**TOWN OF WATERFORD, CT
PLANNING & DEVELOPMENT**

**Re: Application #C 24-11 – 22A Avery Lane
Application Review Comments**

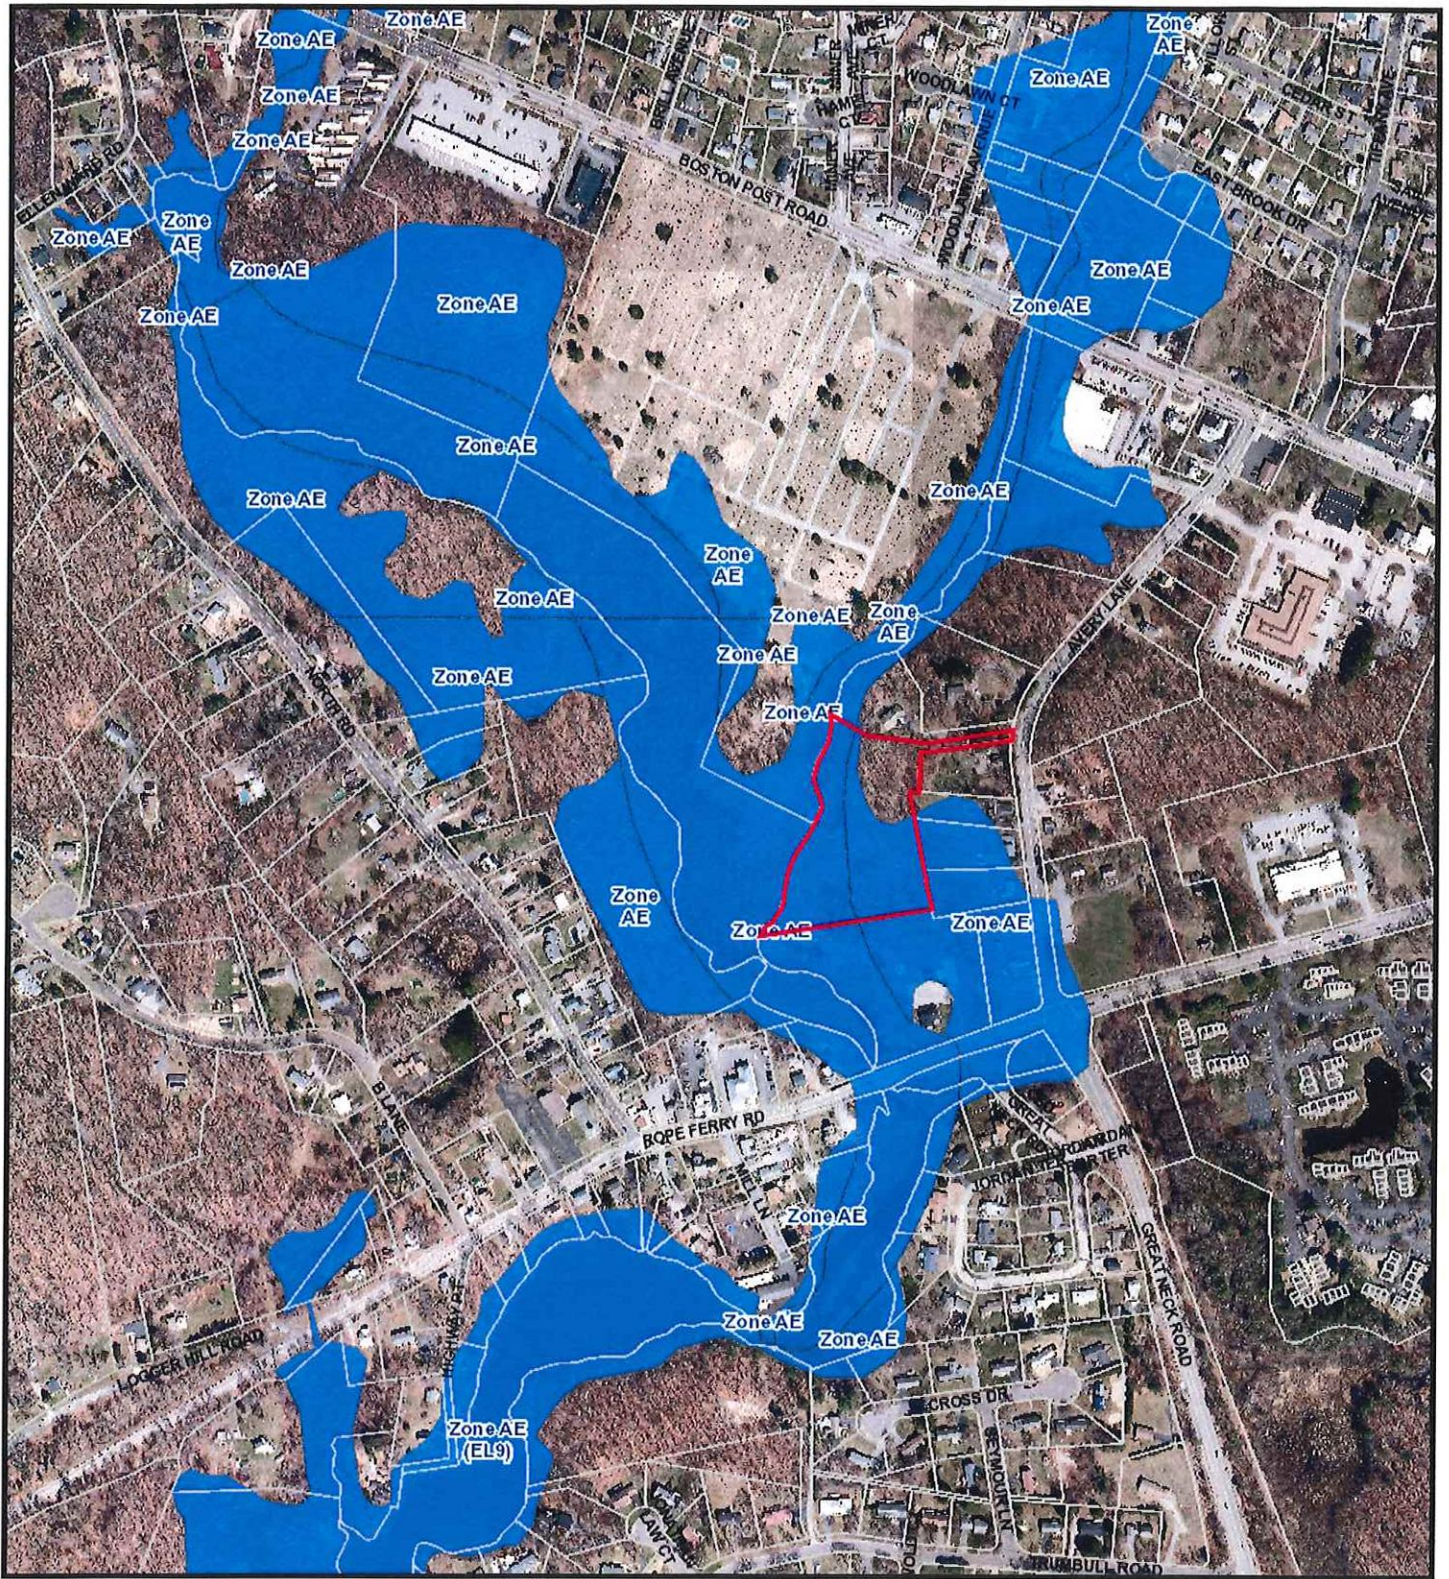
A wetland and watercourses report was included in the application, prepared by Ian Cole, LLC. dated July 2, 2024. The wetland consists of a seasonally flooded wooded swamp with some shrub/scrub open areas bordering Nevins Brook channel and the municipal sewer easement. The wetland soils are mapped as Catden and Freetown mucks, poorly drained. Refer to attached AE floodplain mapping.

Town of Waterford WETLANDS SUMMARY

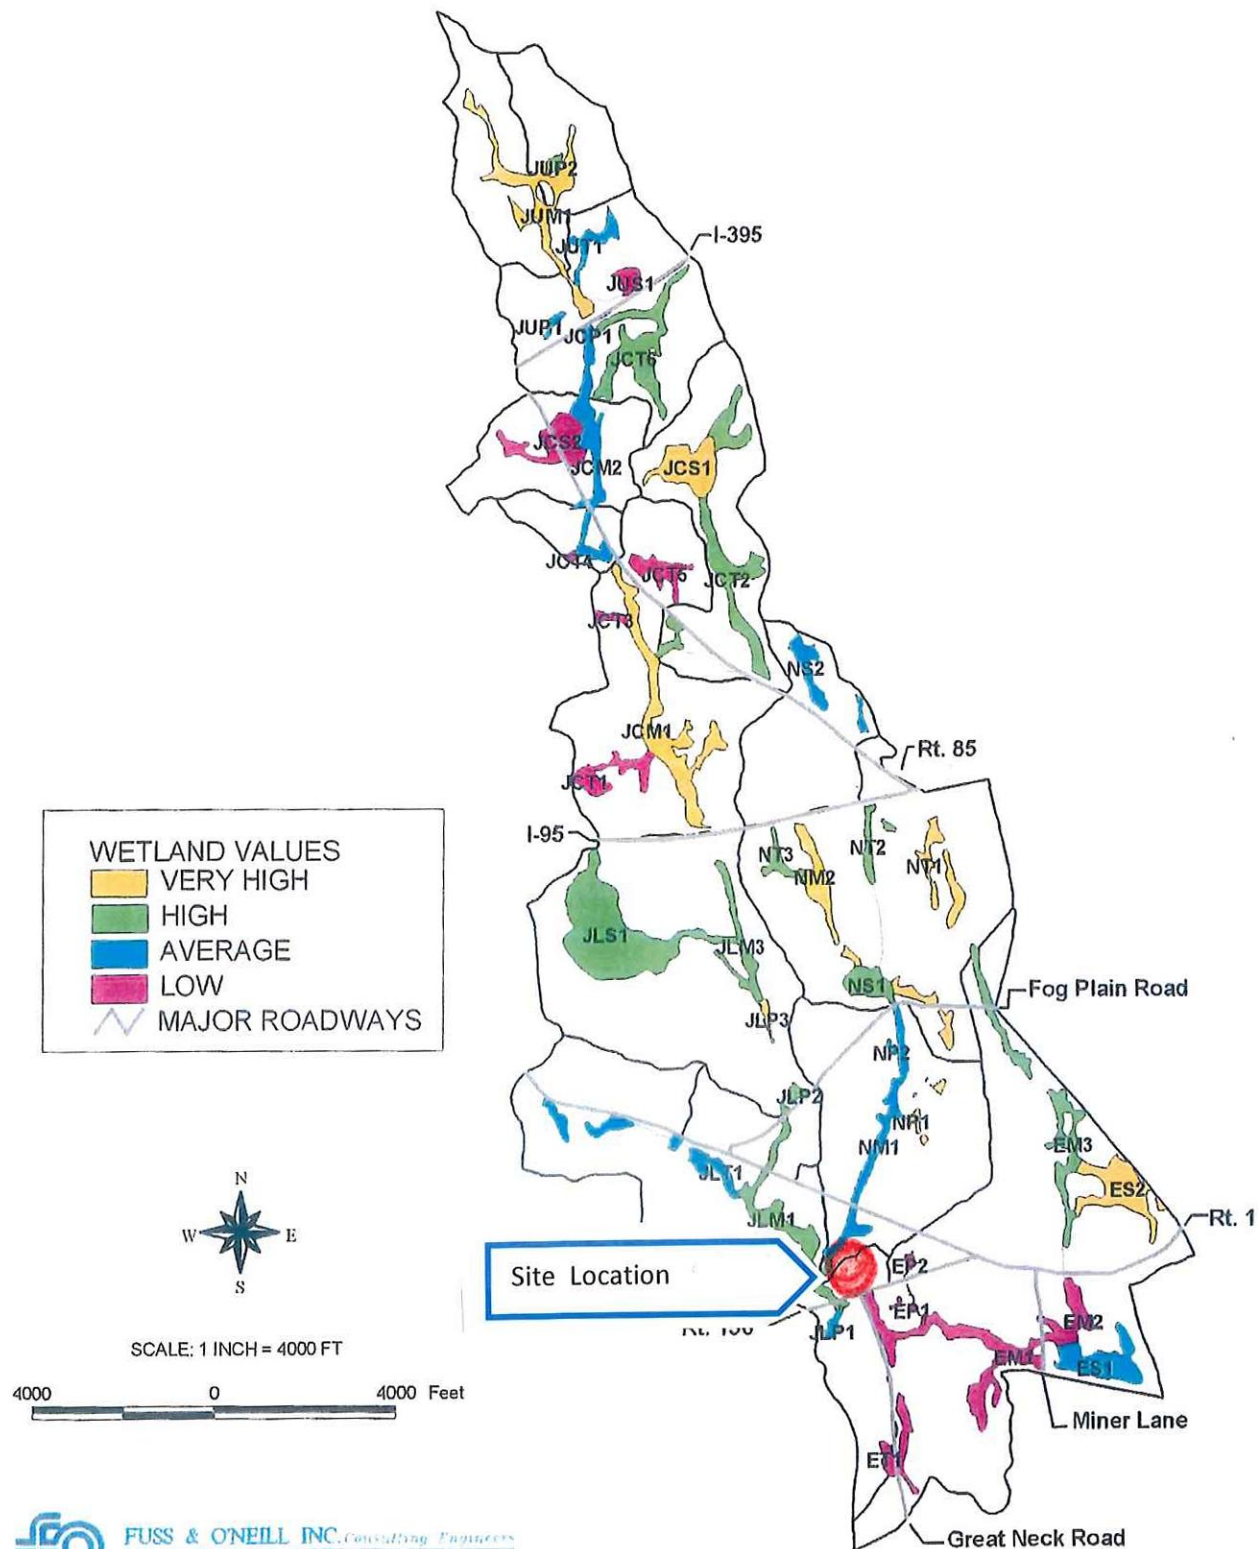
The wetland is part of the Jordan Brook watershed and is identified in the watershed management plan as NM-1, part of the Nevins Brook mainstem. The relative wetland value assigned to NM-1 is average for the watershed. (Refer to attached wetland summary map).
